TAMIL NADU ARCHIVES

G.O. No. 1120.W. Press.
B.P. No. Mis.

ORDER—dated 5th May 1884, No. 1120 W., Public Works.

Censuring officers concerned in the badness of the woodwork used in the construction of the gallery at the —.

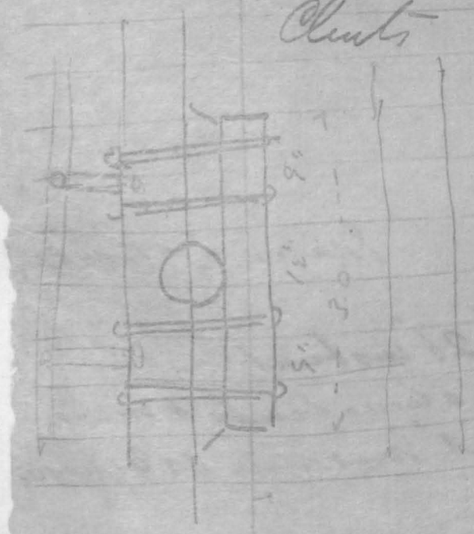
Some of the new Cast iron Column girders over the Main Entrance have broken. The girders are 6"×9" and 3 metres long. The breadth is cut as much as possible to receive them. The round columns on one side and stand up inside as others side forward by iron bolts as per sketch. Please inform if this will be sufficient.

Put a fish plate 9" × 3" with Cleats bolt with 4 ¾" bolts

Museum ——— Elevation of South Wall

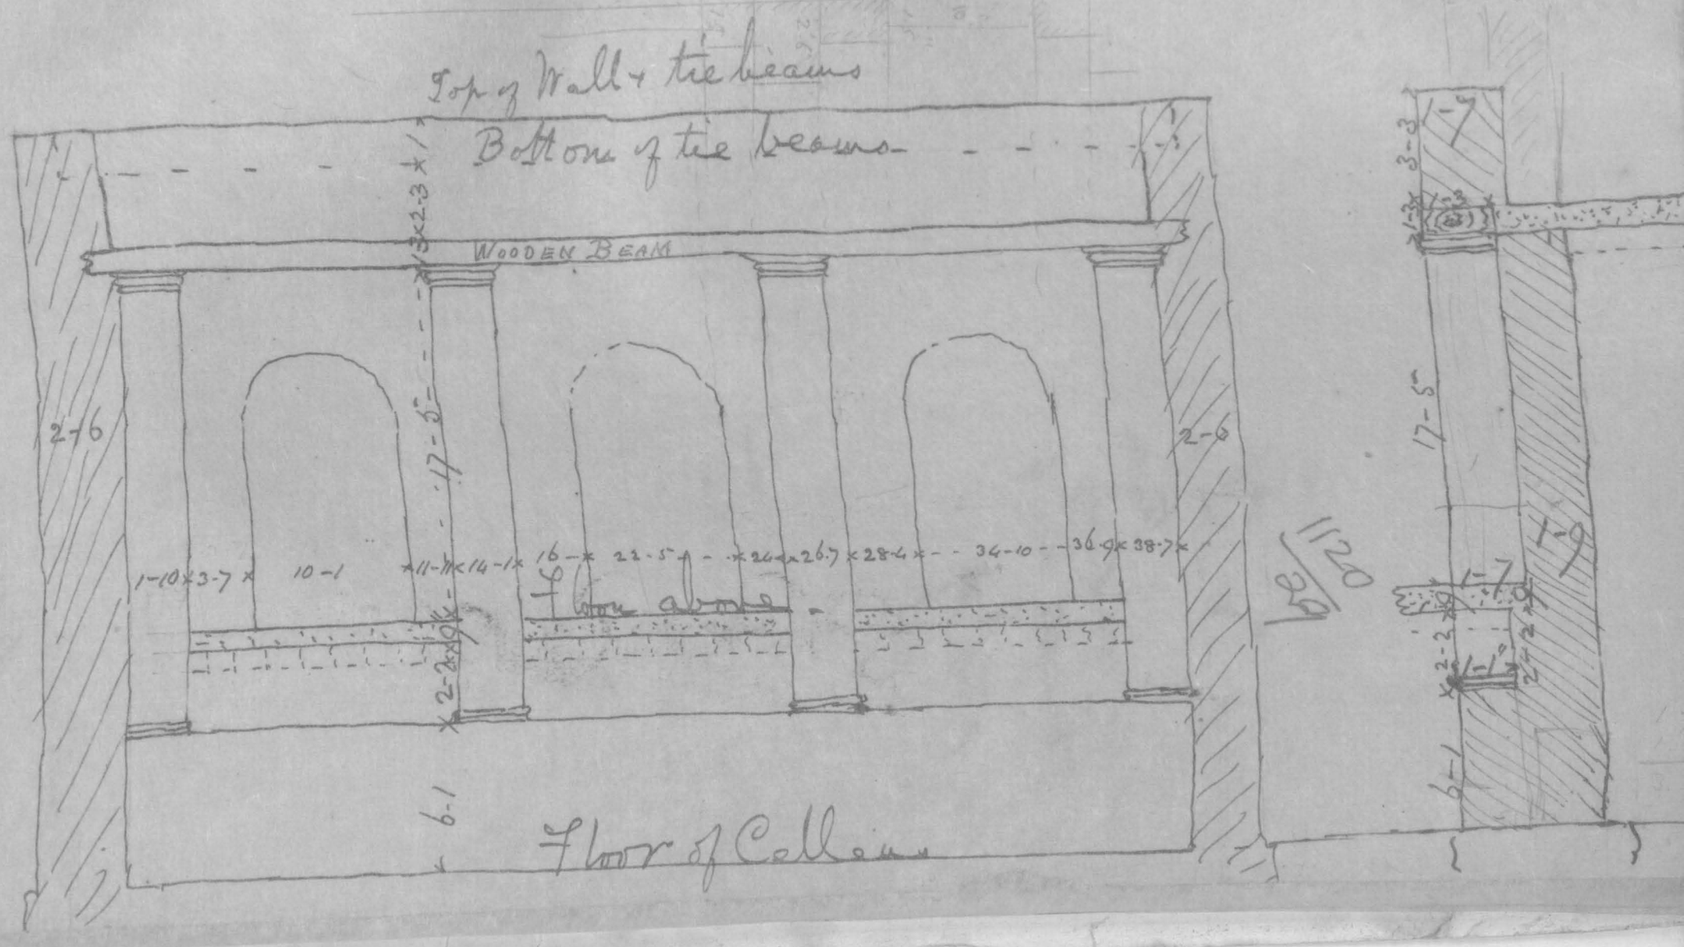
Relieving arches to be put in on each side over both 2nd 3rd & 4th openings from the South side, Arches to be semicircular, 1½ brick.

do do, but segmental arches to be put in over entrance doorways on North side, 2 bricks thick.

The about cracks to be very carefully filled in cement
